DESCRIPTIVE REPORT

Registry No. H-11113

General Locality Sitka Sound

Descriptive Report to Accompany Hydrographic Survey H11113

Figure 2. H11113 Junction Surveys.

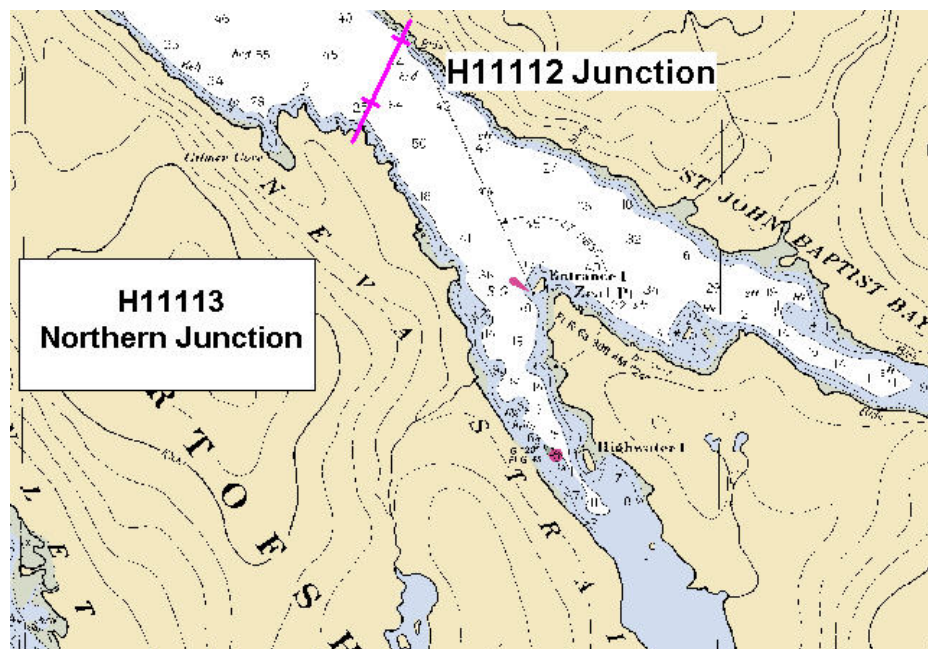
The following contemporary survey junctions with H11113:⁵

Registry #	Scale	Date	Junction side
H11112	1:10,000	2003	North

Survey H11112 junctions well with this survey, a cursory comparison indicates differences are generally less than one fathom.⁶

Final comparisons will be made at the Pacific Hydrographic Branch (PHB) after the application of smooth tides.⁷

⁵ Survey H11113 also junctions with H11114 (2004) and H11115 (2004).

⁷ All junction surveys compared within 1 fathom or less. The junction with survey H11113 and surveys H11112, H11114 and H11115 are complete. A "Joins" note has been added to the smooth sheets where applicable.
